Our Case Number: ABP-319866-24

Re: Proposed development known as North Irish Sea Array ("NISA") Offshore Wind Farm
Located off the coast of Counties Dublin, Meath and Louth (www.northirishsearraysid.ie)

Re: Planning Application by North Irish Sea Array Windfarm Ltd (NISA)

ABP Case Ref OA29N.319866

Image 1.9: Section 14B.1 Full Road Closure Diversion Route

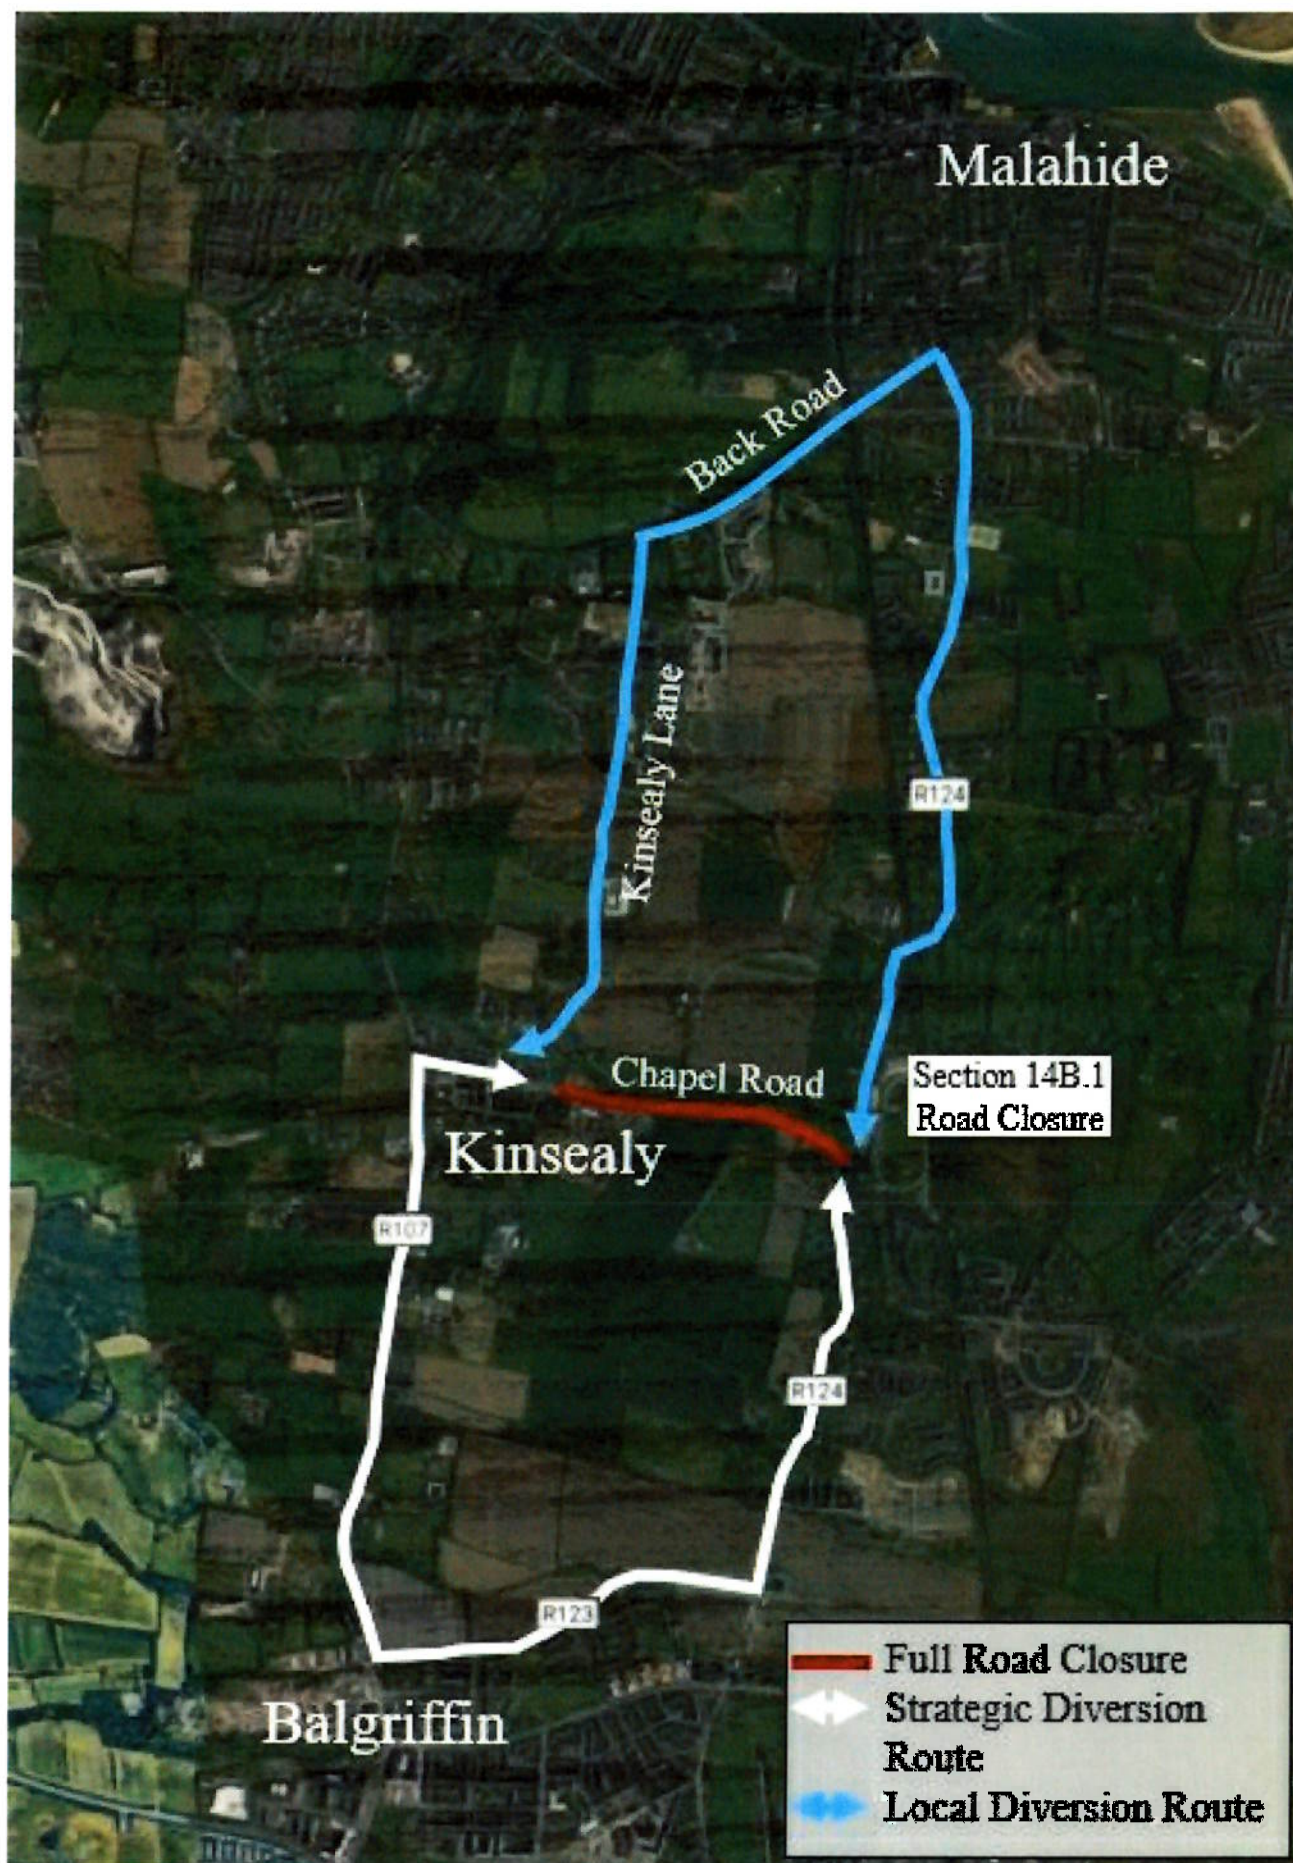
The applicant proposes that the considerable volume of traffic between Malahide and Dublin City, currently using the Malahide Rd. including a substantial volume of commercial vehicles, could be diverted onto the R124, when the Malahide Rd. is closed between Chapel Rd. and the Swords Rd. Image 1.7. This road, despite its designation as a regional road, is substantially substandard, particularly on the section between Blackwood Lane and Chapel Rd. where it passes under the railway, and has a height restriction of 3.15m, thus precluding its use by many commercial vehicles. The same constraints on the R124 apply if Chapel Rd. is closed as this road is propose as the diversion route, Image 1.9

In addition the R124 serves three major schools viz. St Andrews primary school, Oliver Plunkett's primary school and Malahide Community School, Pobal Scoil Íosa. Together these have a student population of c. 2750 and teacher numbers of over 250. As a result the R124 is already subject to severe traffic congestion at school opening and closing times. Thus this proposed diversion route is also totally unrealistic.

Image 2.3: Section 13 (north) Full Road Closure Bus Diversion Route

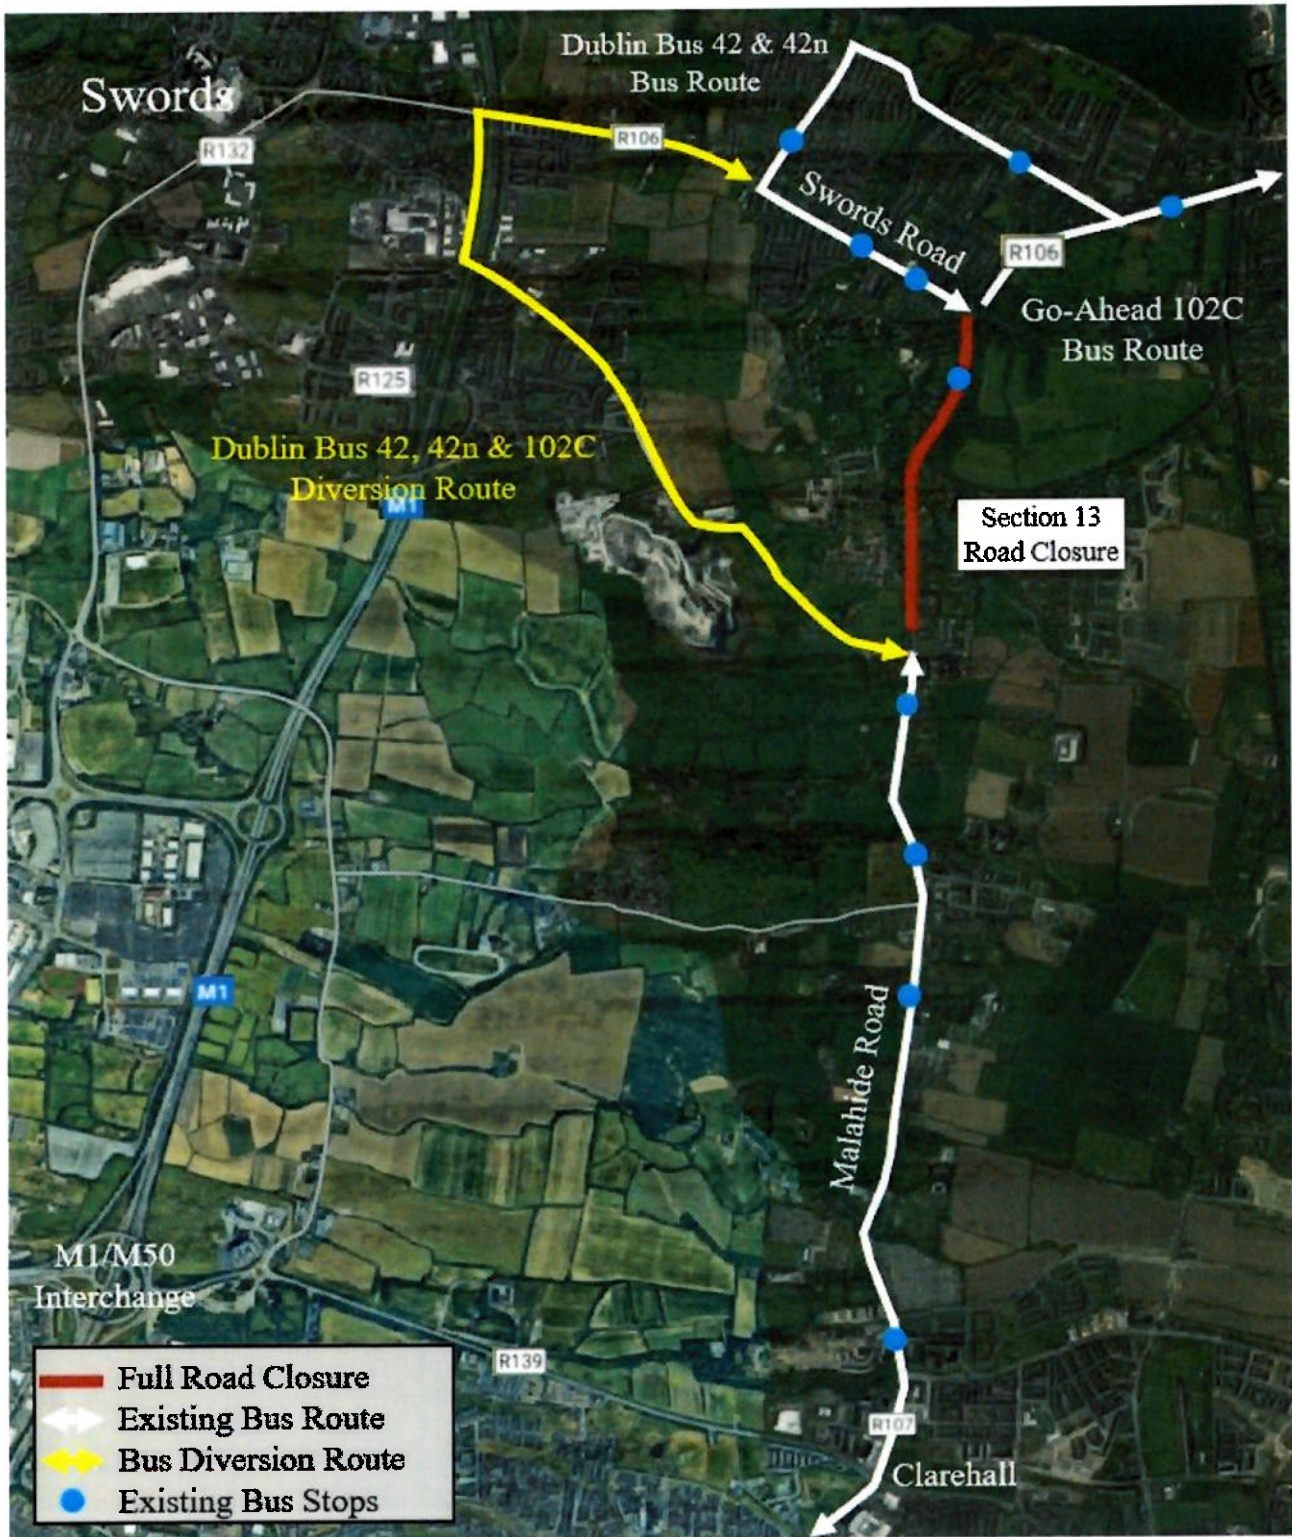
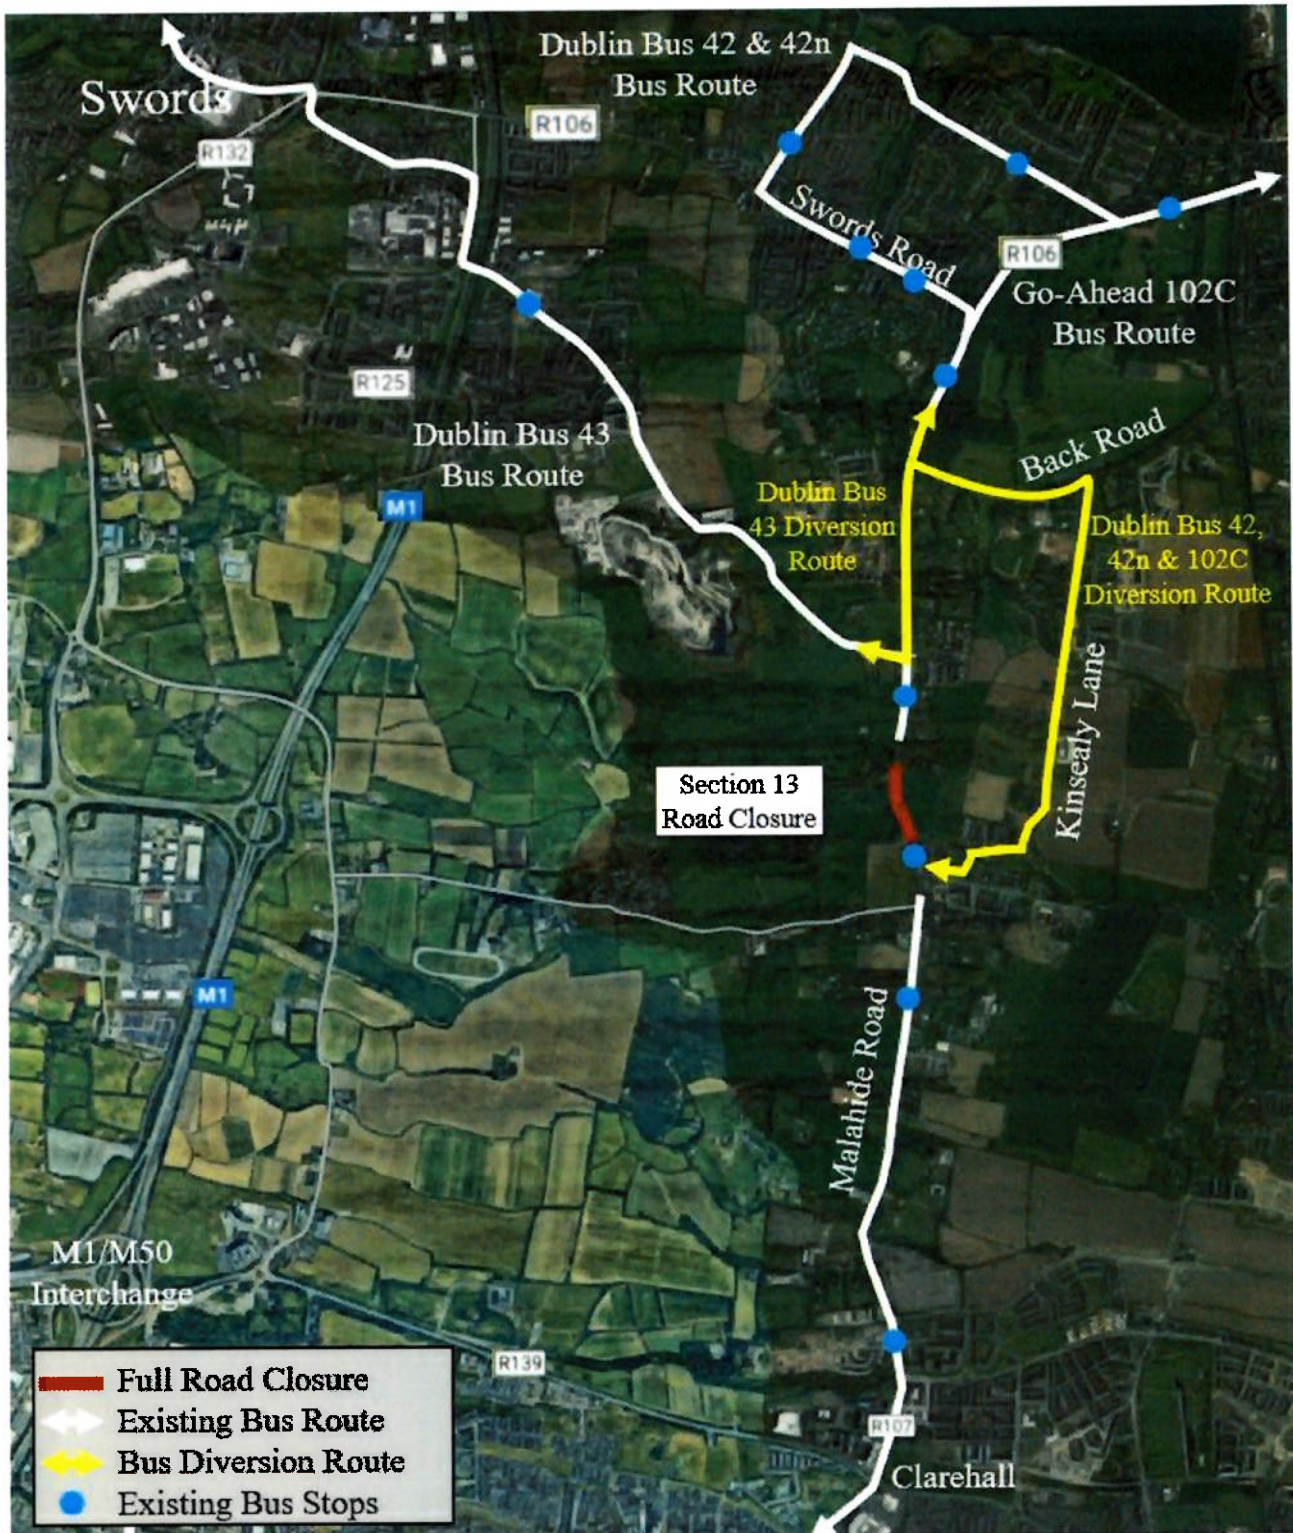
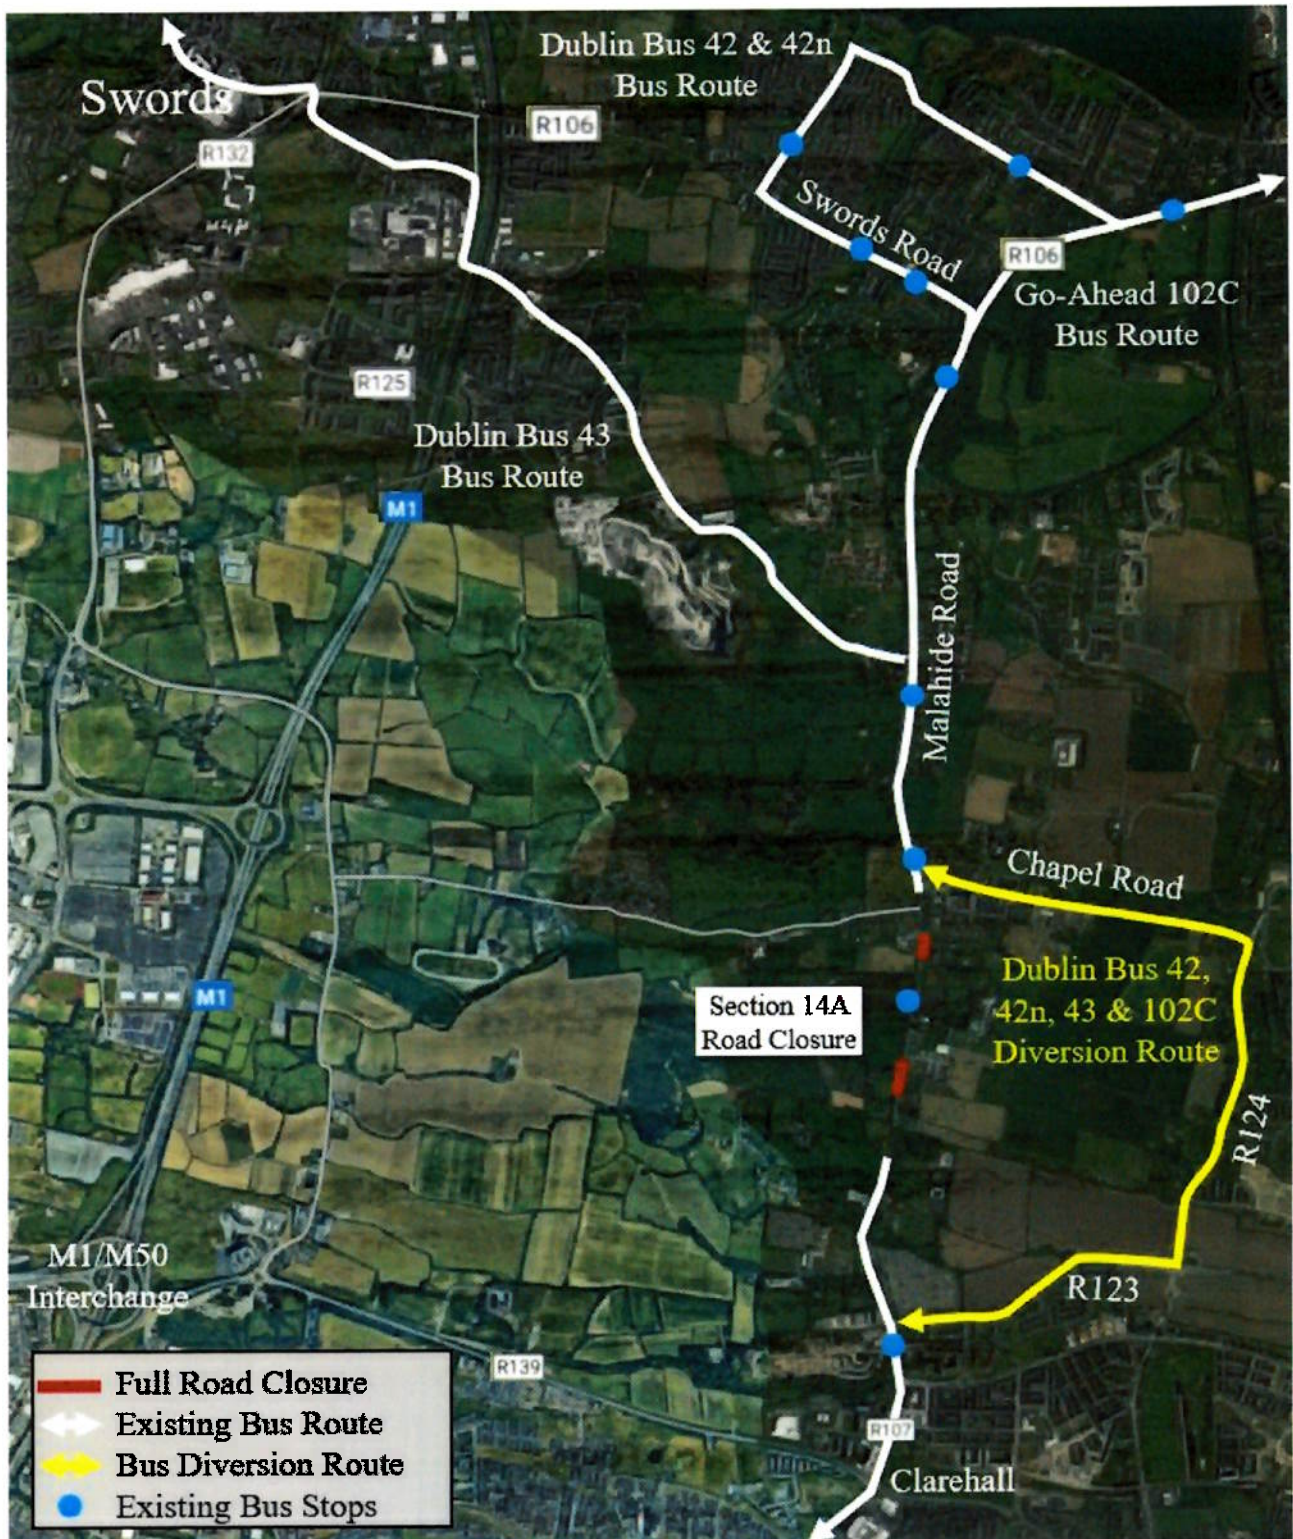
The bus diversion route proposed in Images, 2.3, 2.4 and 2.5 are equally impractical and unrealistic.
